Subject: GT500A,B FRONT FENDER  
MOUNTING METHOD

Bulletin No: GT-39  
 Date: December 2, 1977  
 Read and Initial \_\_\_\_\_  
 Manager: \_\_\_\_\_  
 Parts: \_\_\_\_\_  
 Service: \_\_\_\_\_

TYPE 1

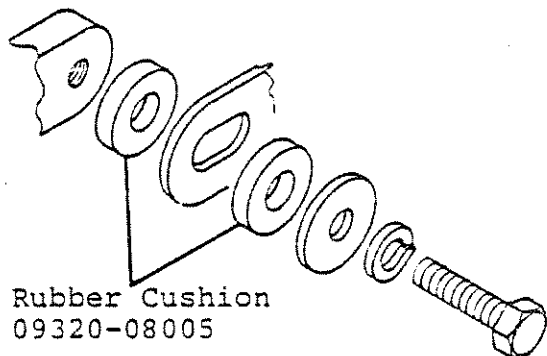
The Type 1 method is a "semi-floating" mount. A rubber cushion is used with the original type fender to provide a small amount of flexibility. With this type of mount, the mounting bolt must be secured with thread lock cement.

TYPE 2

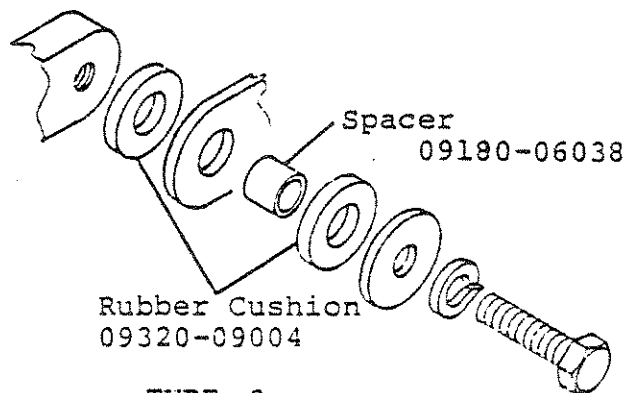
There are presently three ways to mount the A and B model GT500 front fender brace to the front fork outer tube. To distinguish the different mounting methods from each other, they are labeled the Original method, the Type 1 method, and the Type 2 method. If any original or Type 1 front fender has to be replaced, it must be updated to the Type 2 fender.

The Type 2 method is a "floating" mount. The front fender brace has been changed and it is mounted by a rubber cushion and a spacer. This mounting method will provide a secure yet flexible mount for the front fender.
